TOWN OF COTTAGE GROVE
PLAN COMMISSION MINUTES
FEBRUARY 26, 2025

To: Kim Banigan, Town of Cottage Grove Clerk
FROM: Mark Roffers, Town Planner
Cc: Nick Bubolz, Town Engineer; Bill Cole and Chris Nelson, Town Attorney
DATE: February 19, 2025
RE: Kennedy Hills First Addition Final Plat

Subject: Proposed Kennedy Hills First Addition – Final Plat Submittal Review

RE: Viney Acres Business Park Concept Plan/Comprehensive Development Plan

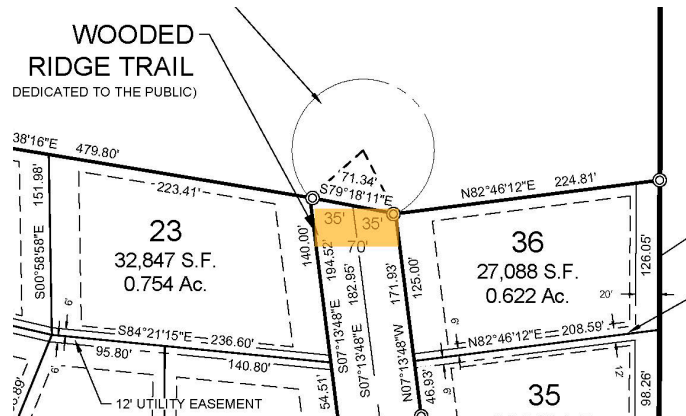
3. The final plat and engineering plans continue to include a full, temporary cul-de-sac bulb at the north end of the to-be-extended Wooded Ridge Trail, despite the following condition of Town preliminary plat approval: “The Developer shall replace on the preliminary plat and engineering plans the current cul-de-sac bulb at the northern terminus of current Wooded Ridge Trail with a hammerhead turnaround within the dedicated right-of-way, of a design approved by the Town Engineer.” This condition was intended to minimize the removal of trees in a location that will prove unnecessary once Wooded Ridge Trail is extended further north in the future. The project engineer’s response seems to indicate need for further direction. My general thought was to

substitute a hammerhead turnaround in the area marked in gold on the plat crop to the right, but I welcome interaction between the project and Town engineers on final design with the dual goals of providing a reasonable temporary turnaround and limiting tree removal. In the meantime, the associated preliminary plat approval condition should be carried forward to the final plat approval.
